ASB-1010

Service Bulletin

Subject: AT-50 Blows ACCY Fuse in TS-50S

Date: April 30, 1993

X53-3470-00 D/4
Foil Side View

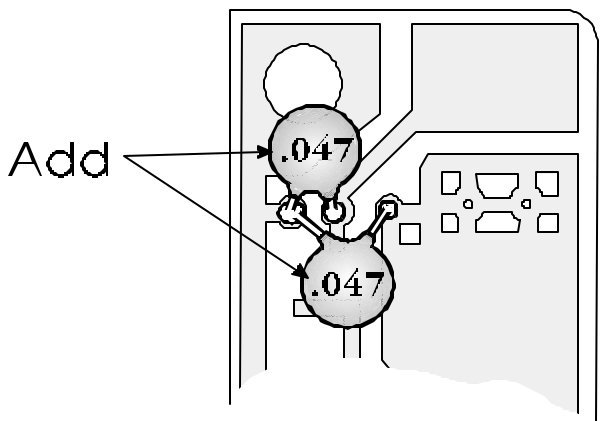
Attempting to tune the AT-50 when it is connected to an antenna with a relatively high SWR value might cause the ACCY fuse to open in the TS-50S. This change will correct this tendency.

1. Remove the top cover from the antenna tuner.
2. Locate X53-3470-00 D/4 (It is attached to the top left side of the chassis with the foil side up.)
3. Add the two .047 μ F capacitors as shown in the drawing below.
4. Replace the top cover.

Qty	Description	Kenwood Part No.
2	.047 μ F disc ceramic capacitors	CK45B1H473Z
